Sustainable Communities Environmental Assessment Errata

5001 Wilshire Project

Case Number: ENV-2021-3327-SCEA
DIR-2021-3324-CLQ, DIR-2021-3326-TOC-SPR-VHCA, VTT-83358

August 2022

FIGURE II-11

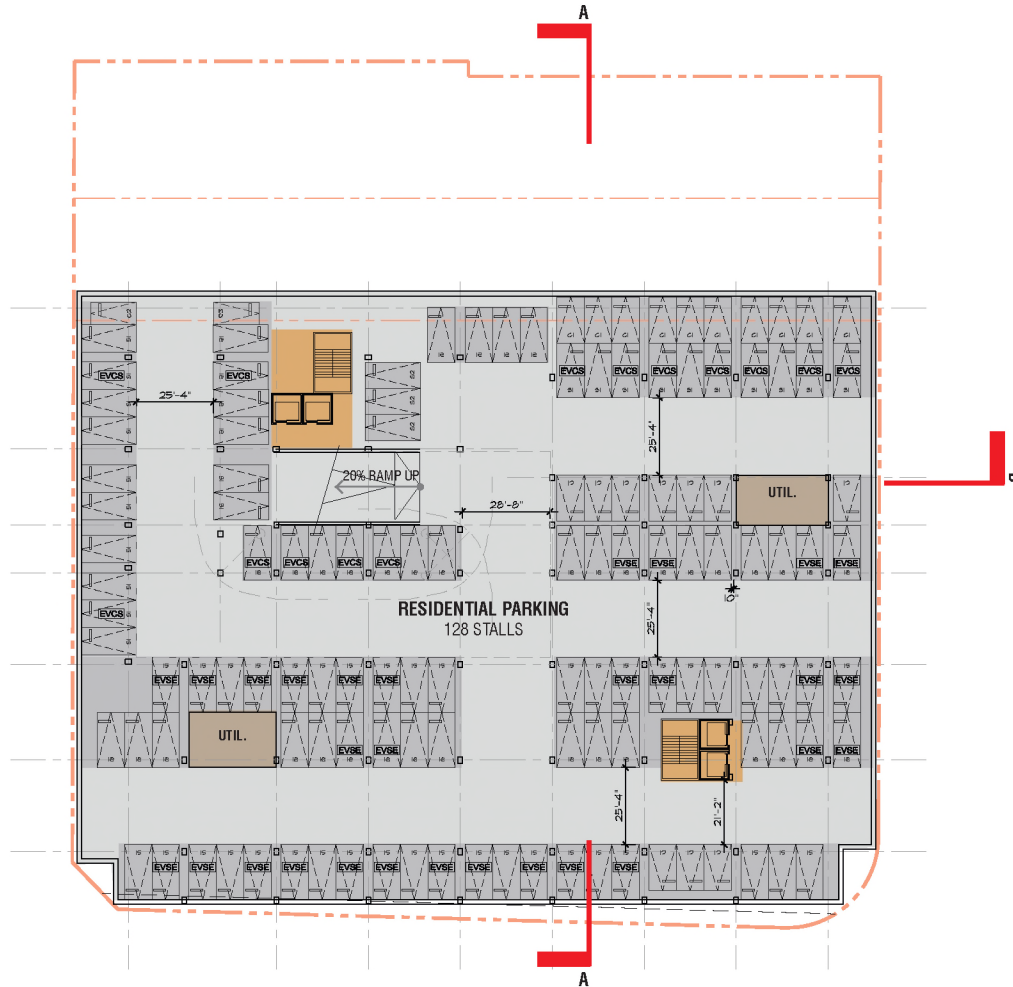
Figure II-10 Basement 1 Floor Plan - this figure reflects minor updates made to the arrangement of the residential parking stalls.

FIGURE II-21

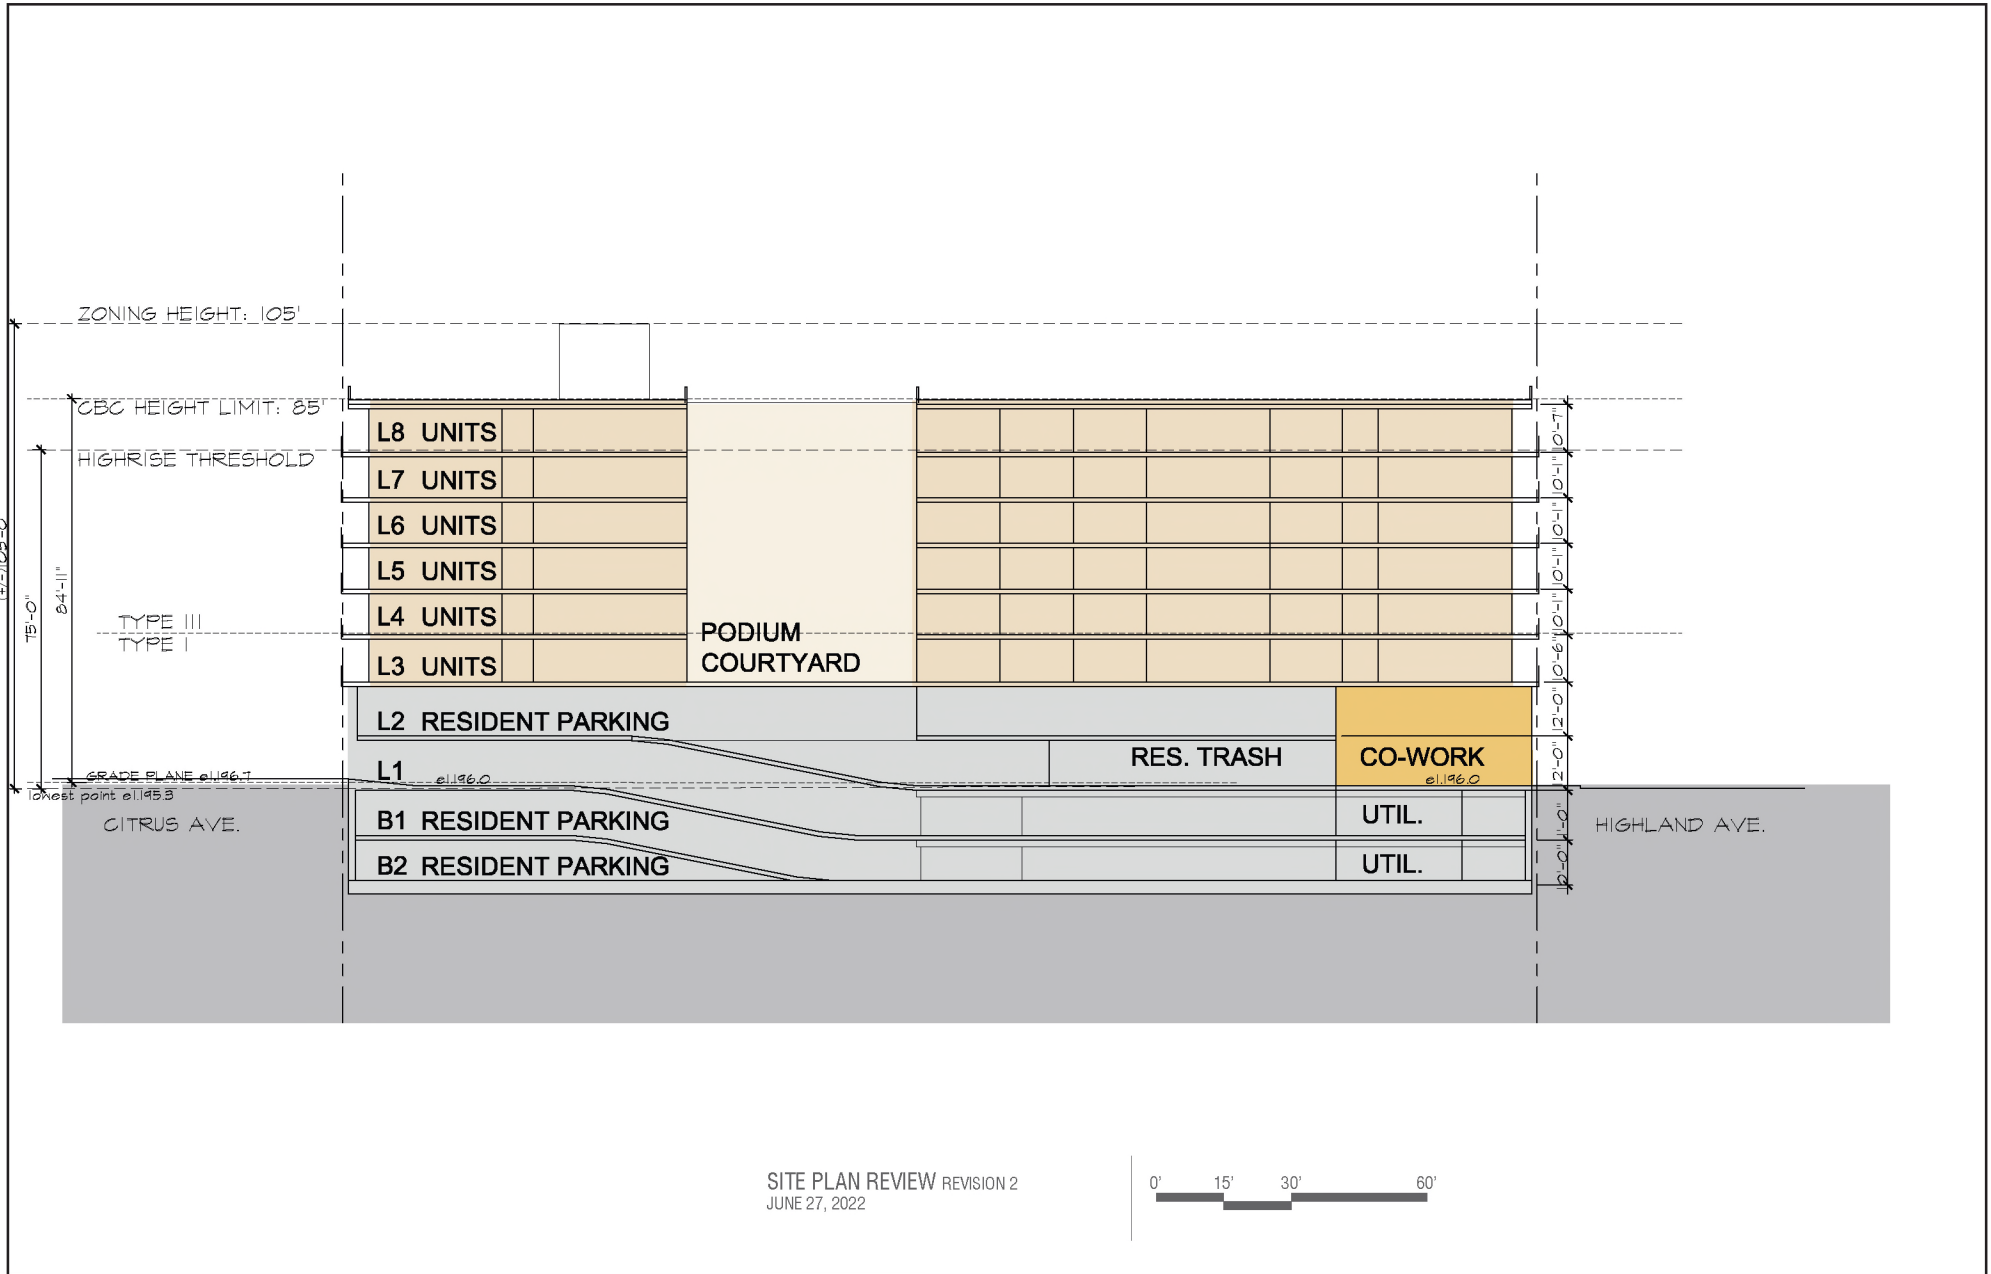
Figure II-21 East Elevation - this figure reflects minor updates made to the building exterior and demonstrates that the updates made to the subterranean and above-grade parking do not cause any changes to the building's exterior.

FIGURE **II-23**

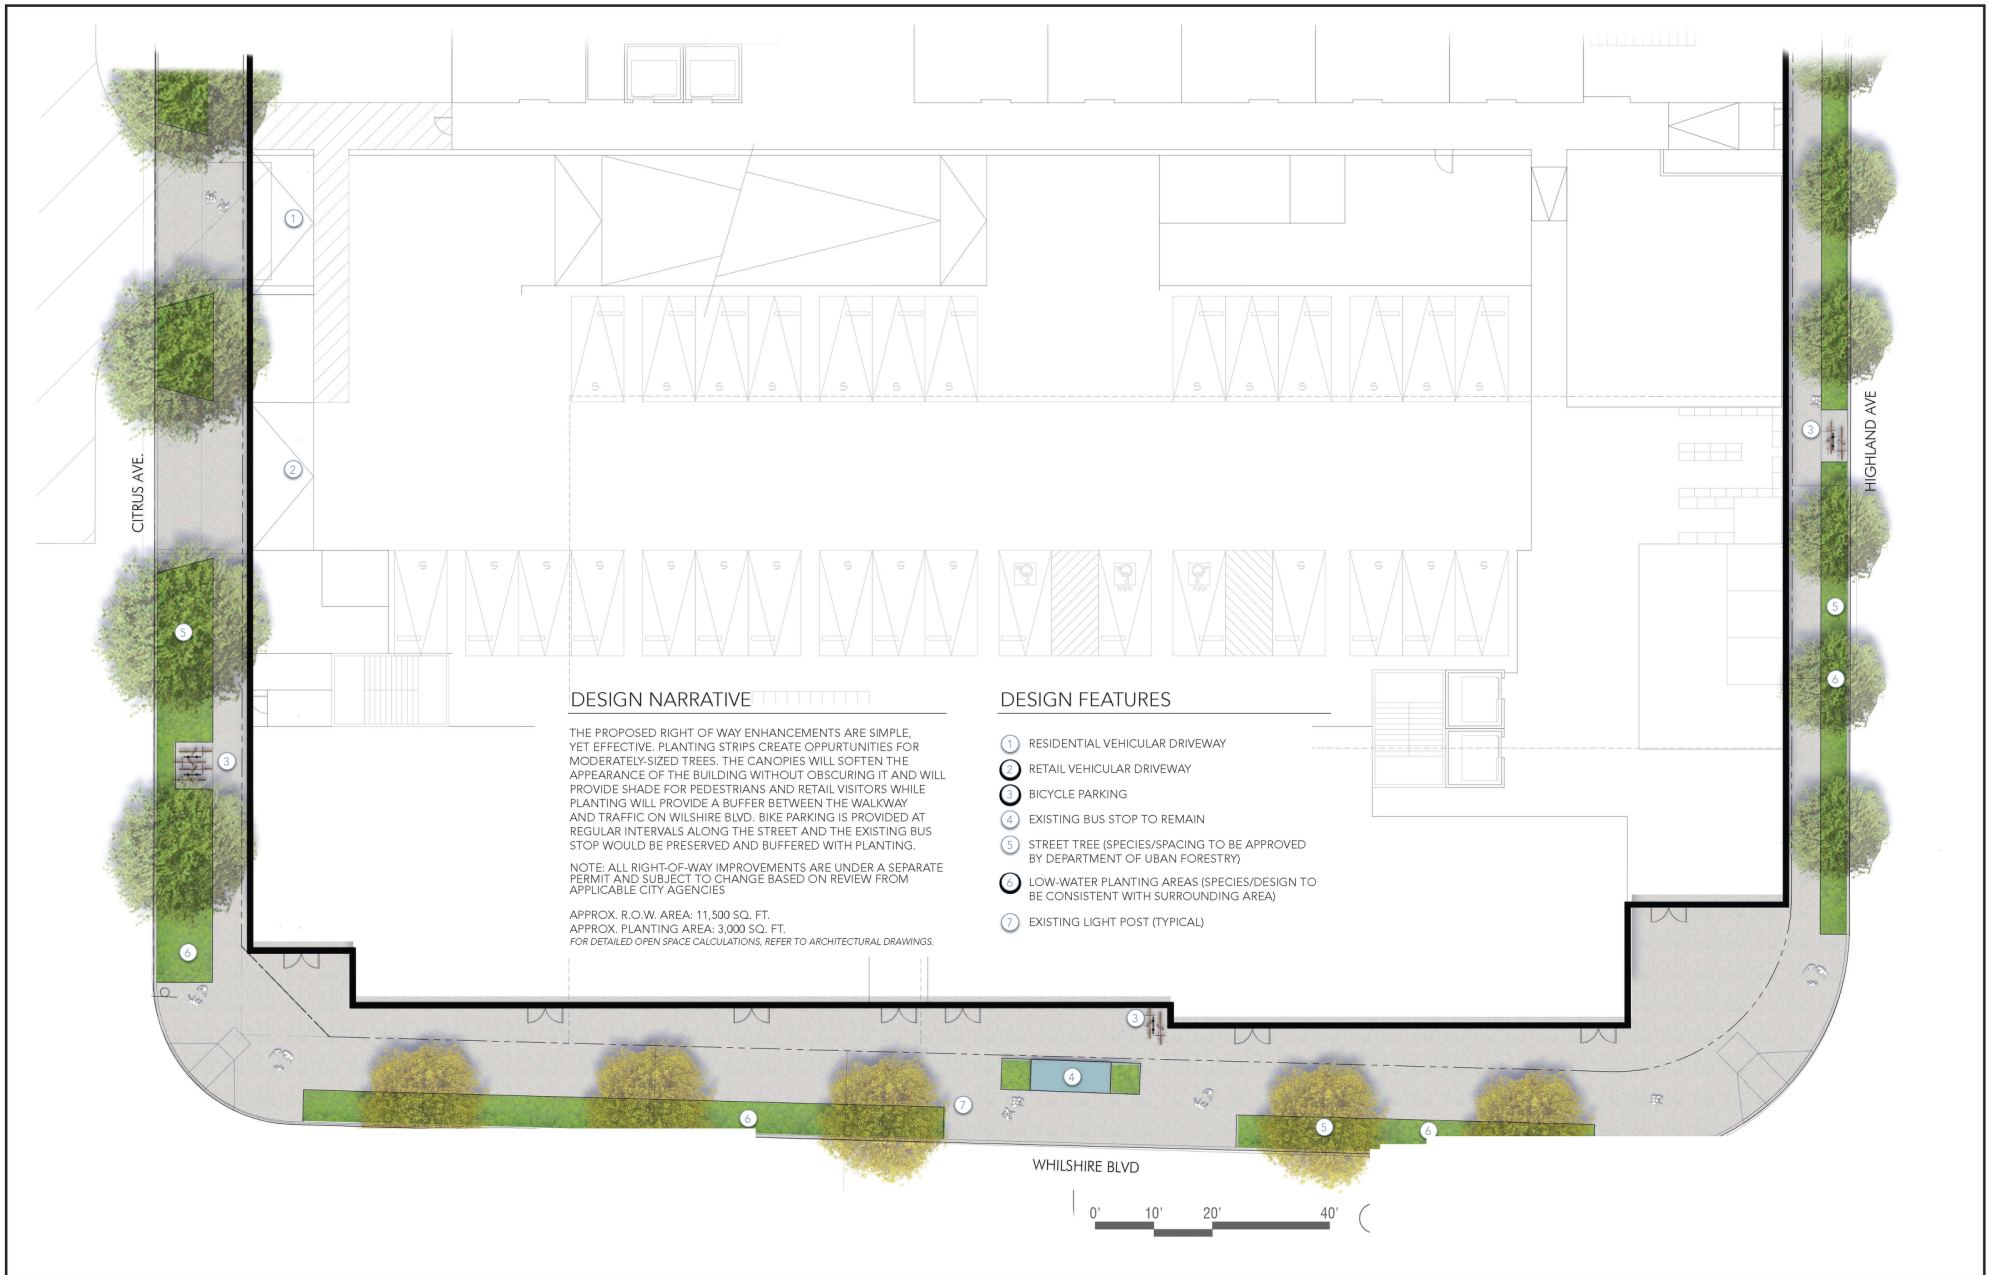
Figure II-23 Site Section B - this figure reflects the updates made to the building levels as a result of the elimination of the third subterranean parking level and the addition of the above-grade parking level, which also results in the reconfiguration of some storage areas and co-working areas.

FIGURE II-24

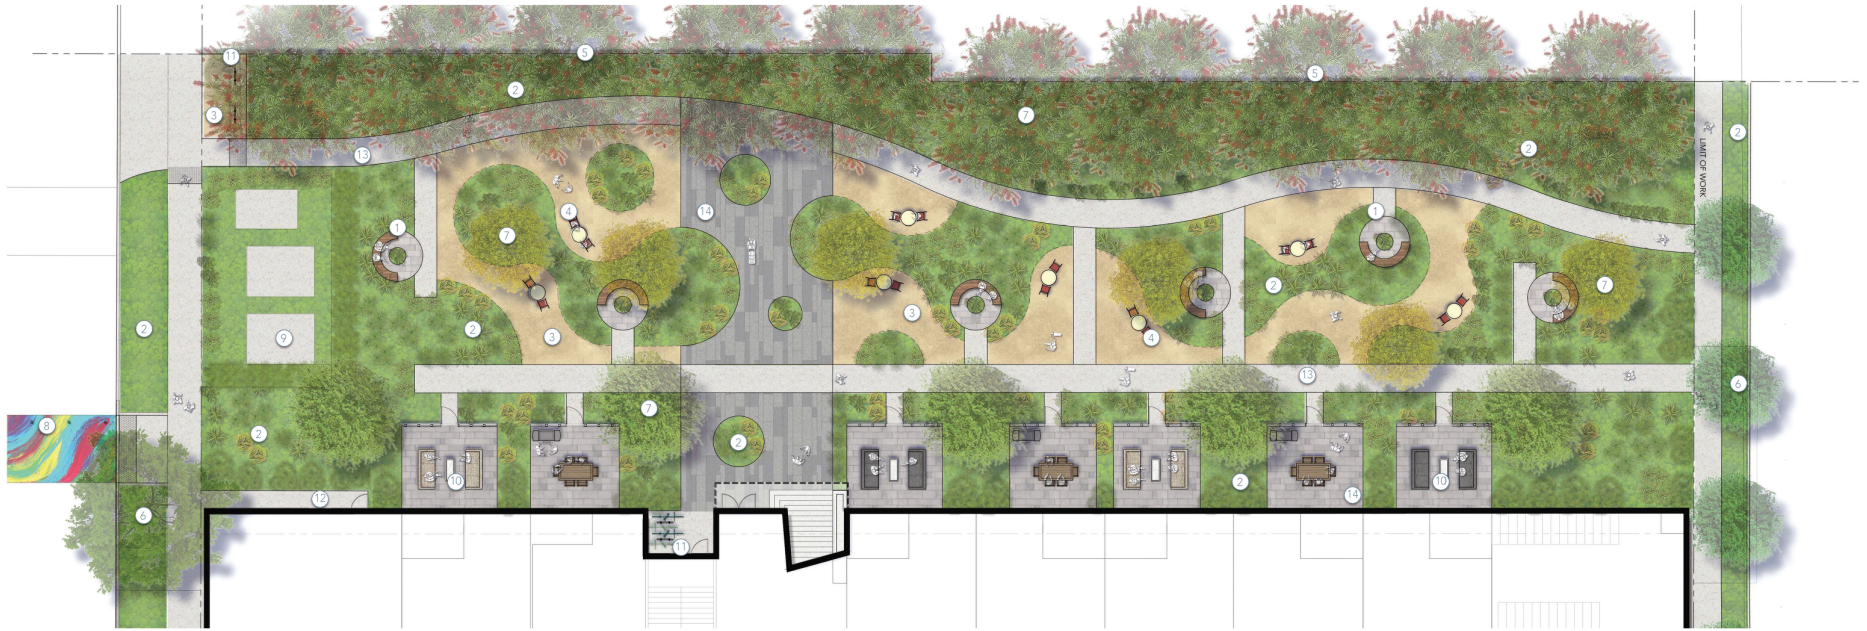
Figure II-24 Conceptual Right of Way Plan - this figure reflects the updates made to the configuration of the ground level (commercial) parking.

Figure II-34 – South Citrus Avenue Closure Exhibit

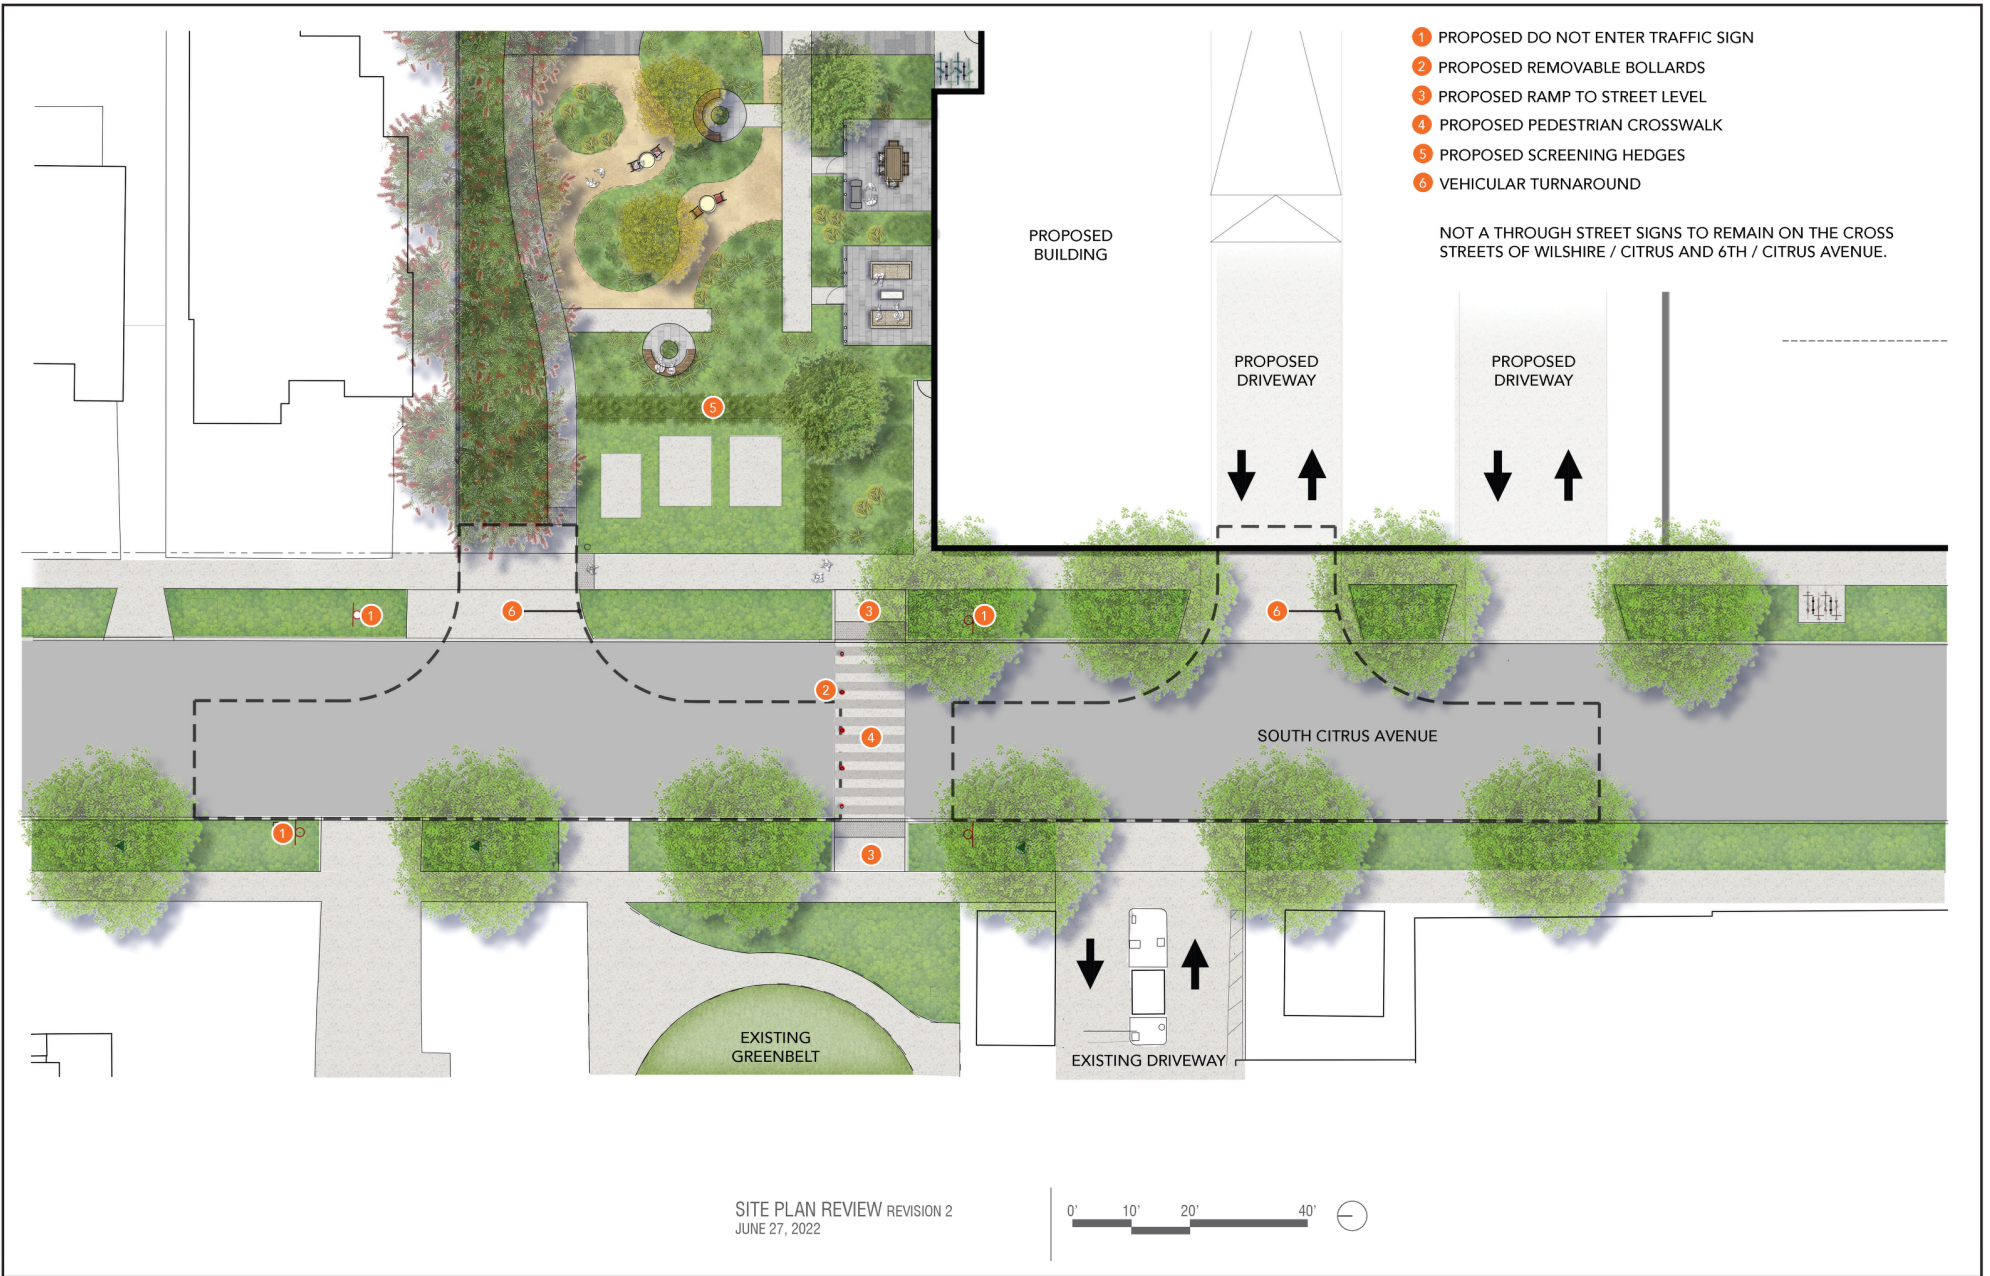
This figure was added to clarify the proposed design of the street crossing and illustrate the placement of signage and bollards on South Citrus Avenue; as included the analysis in the Transportation Assessment (Appendix H of the SCEA); this addition does not constitute new significant information, and does not change the analysis or conclusions in the SCEA pursuant to CEQA Guidelines Section 15088.5.
